Subject: REVISION: N242485780-01 - Service Update
Power Steering Pump – Service Procedure
Revised Parts, Warranty Information, and Service Procedure

N242485780 Power Steering Pump

Revision: 01

Revision Description: This bulletin has been revised to update the parts, warranty information, and service procedure. Please discard all previous copies of bulletin N242485780.

6817376

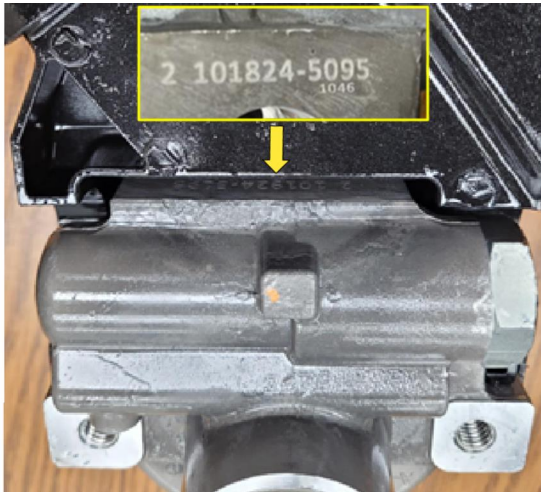
2. Insert a right-angle borescope behind the power steering pump pulley, from the most accessible side horizontally along the top edge of the Power Steering Pump. The date code and lot code are located on a flat between the reservoir and pump body as pictured below. Angle the camera towards the engine, as the codes are inside of the gap beneath the reservoir.

NOTE: Pulley removed to show location, it is NOT required to remove the pulley for borescope inspection. As pictured above, Date Code: 101824 Lot Code: 5095

3. Verify the Date Code Range (6 digit) does not fall between 100424 and 102624.
 - If the code **IS NOT** between 100424 and 102624, the power steering pump is within specification and no further action is required.

- If the code **IS** between 100424 and 102624, proceed to step 4.
4. Verify the Lot Code Range (4 digit) is not within the 5xxx series, seen as 5xxx.
 - If the code **IS** within the 5xxx Lot Code Range, the Power Steering Pump **MUST** be replaced. Refer to *Power Steering Pump Replacement* in SI for instruction.
